**CULTURAL RESOURCES OFFICE
PRESERVATION BOARD
REGULAR MEETING
MONDAY – NOVEMBER 23, 2015 — 4:00 P.M.
1520 MARKET ST. #2000
ST. LOUIS, MO. 63103
www.stlouis-mo.gov/cultural-resources**

DATE: November 23, 2015
ADDRESS: 2716 Indiana Avenue
ITEM: Preliminary Review: construction of a new single-family house
JURISDICTION: Benton Park Local Historic District — Ward 9
STAFF: Jan Cameron, Cultural Resources Office

DATE: November 23, 2015
ADDRESS: 2858-62 Indiana Avenue
ITEM: Preliminary Review: construction of three detached single-family houses.
JURISDICTION: Benton Park Local Historic District — Ward 9
STAFF: Jan Cameron, Cultural Resources Office

DATE: November 23, 2015
ADDRESS: 4104-56 DeTonty Street
ITEM: Preliminary Review: construct 2 apartment buildings and four 2-family buildings
JURISDICTION: Shaw Certified Local Historic District — Ward 8
STAFF: Jan Cameron, Cultural Resources Office

FRONT FACADE

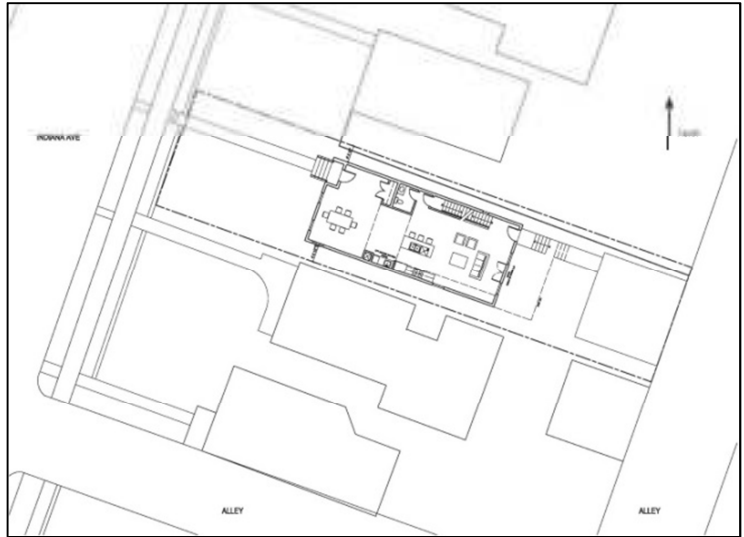
Partially complies. The windows of the front elevation are generally compatible with adjacent residential buildings, although they do not duplicate their details and trim, nor do they follow those of the Model Example.

However, the front façade presents a 2-story entry bay that rises to a wide wall dormer with large fixed window. The elements of this bay do not approximate the proportions of any similar elements on building in the district and the dormer design is prominent in the front façade.

Complies. The fenestration and entry on the Public Façade are generally in conformance with historic buildings on the block, although they do not exactly duplicate those of the Model Example.

Complies. The front elevation will be veneered in red brick and will have a substantial return on each side elevation; the side gables will also be filled with brick. The rear portion of each side facade will have cement lap siding, painted a dark gray color.

- The scale of several elements of the front façade has been reduced in the latest drawings and they are more compatible with those of the surrounding buildings.

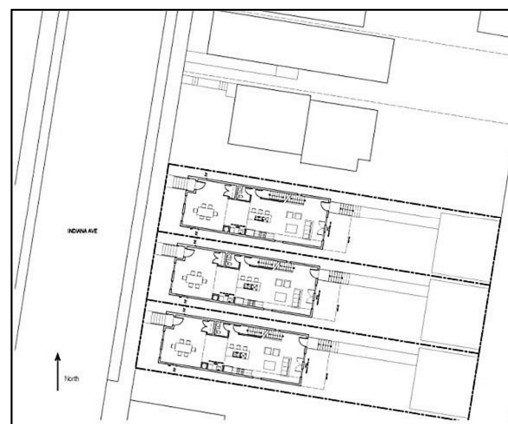
Partially complies. The windows of the front elevation are generally compatible with adjacent residential buildings, although they do not duplicate their details and trim, nor do they follow those of the Model Example.

However, the front façade presents a 2-story entry bay that rises to a wide wall dormer with large fixed window. The elements of this bay do not approximate the proportions of any similar elements on building in the district and the dormer design is prominent the front façade.

Complies. The fenestration and entries on the Public Façades are generally compatible with historic buildings on the block, although they do not duplicate those of the Model Example.

Complies. The front elevation will be veneered in red brick and will have a substantial return on each side elevation; the side gables will also be filled with brick. The rear portion of each side facade will have cement lap siding, painted in a dark gray color.

WESTERN STREETSCAPE (LEFT TO RIGHT):
 WESTERN END OF FOURTH 2-FAMILY—LARGER APARTMENT BUILDING—EXISTING HISTORIC BUILDINGS

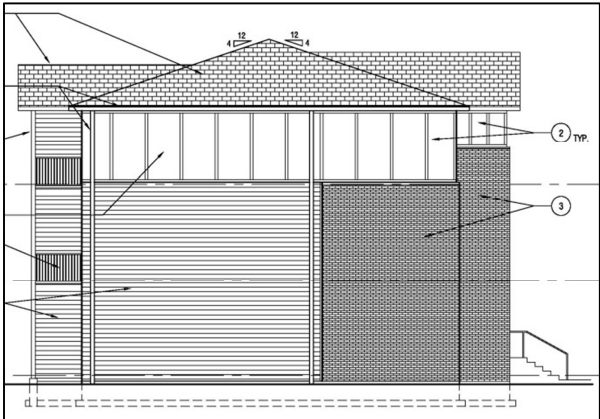
The two apartment buildings will also match floor-to-ceiling heights, but will have three stories and will not comply with this standard. While their design uses cement panels and light color to visually reduce the perceived scale of the third story, it is only partially successful as the third story is not set back, but in the same plane as the rest of the facade.

The third story of each larger building, however, will be sheathed with vertical trim boards. Gabled bays will have horizontal cementitious siding. Both panels and siding will be painted. Siding, if it appears at all in the district, is limited to small architectural details; its use for an entire story is not comparable with surrounding historic buildings.

Does not comply. Roofs of the few remaining buildings on the block are flat: several have false gables or mansards at the front facade. The larger buildings will have complex hipped gables of medium pitch. Front elevations for the smaller buildings suggest that they will have side-gable roofs of moderate pitch.

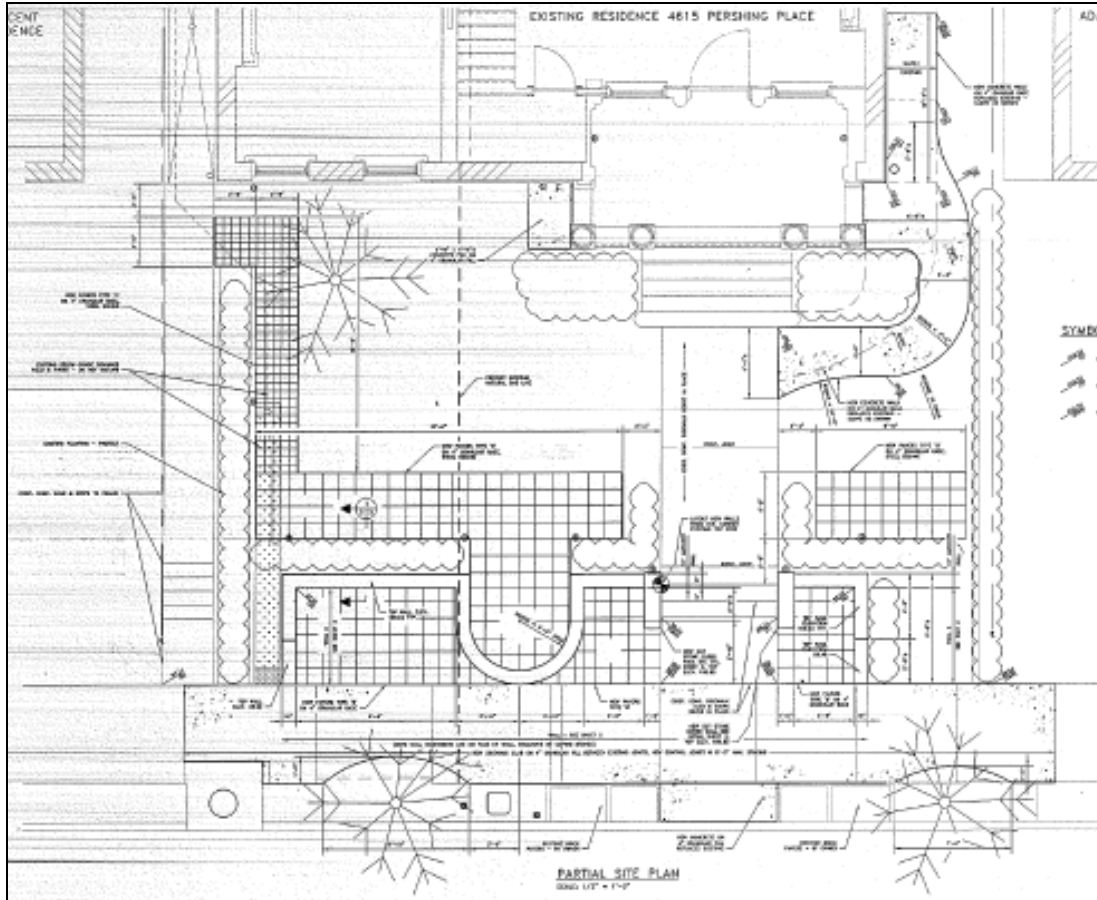
Does not comply. The proposed project would alter the original terrace and introduce a new retaining wall.

ELEVATION

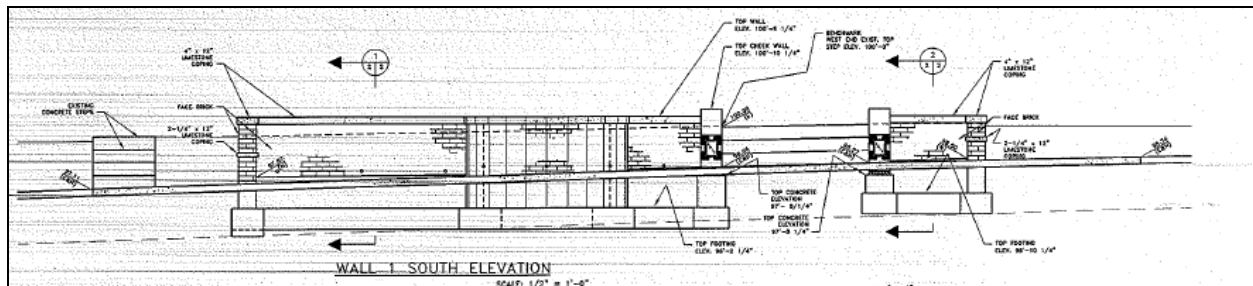
The applicant has applied for a building permit to install a retaining wall in front of the house at 4615 Pershing Place, the excavation for which was started without a permit. The plan intends a reshaping of the earth terrace edge with an elaborate brick retaining wall that includes a projecting curved element and small plaza. The application was denied as the Central West End historic district standards require that original historic earth terraces shall be preserved and that no new retaining walls be constructed. The owner has appealed the denial.
